Reference: Fort DeSoto Seawall & Sidewalk Hurricane Damage Assessment

Opinion of Probable Construction Cost
Fort DeSoto Seawall
Pinellas County
June 2025

Figure 3-1 Seawall Repair Detail Sketch

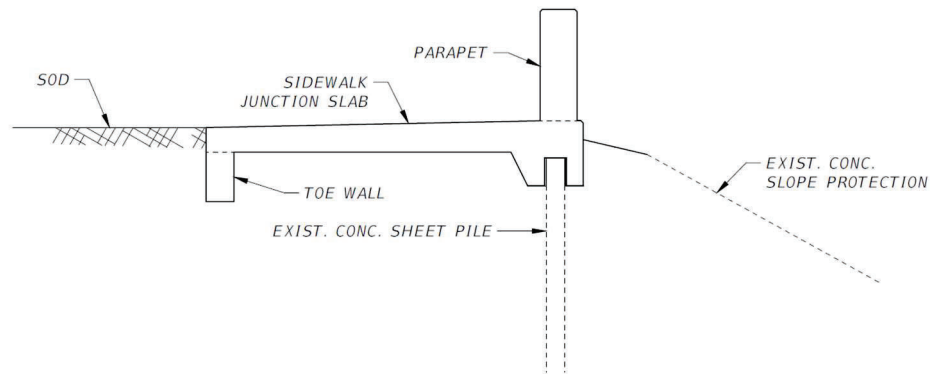
#1: Agree - 250 ft of seawall and sidewalk need to be completely removed and replaced

1. Cut and remove 250 feet of damaged seawall and replace it with a concrete junction slab that combines the sidewalk and barrier wall in a structural component.
